DEVELOPMENT BOARD

ECE3301L SESSION 3 LAB 2

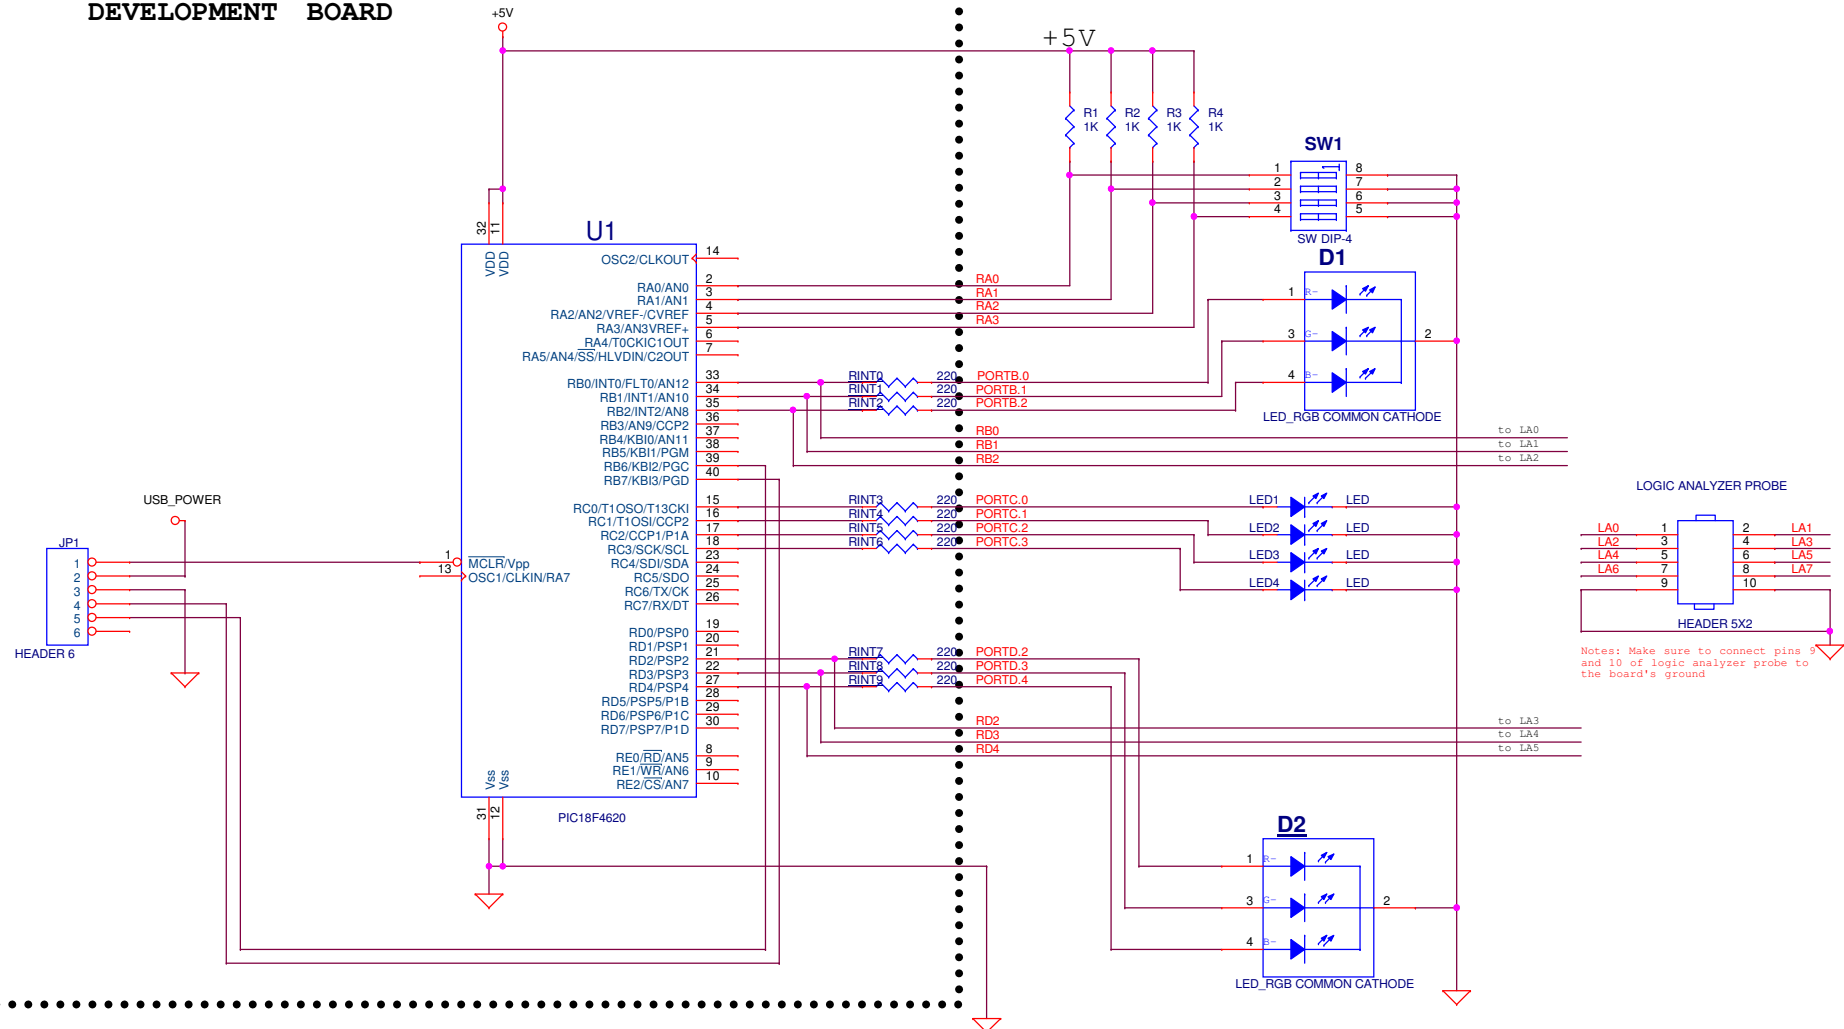
REMOVE THE JUMPER AT JP3 THAT IS CONNECTING PIN 1
TO 2 AND MOVE IT TO CONNECT FROM PIN 2 TO PIN 3.
THIS WILL ALLOW THE SIGNAL 'RA3' TO WORK PROPERLY.
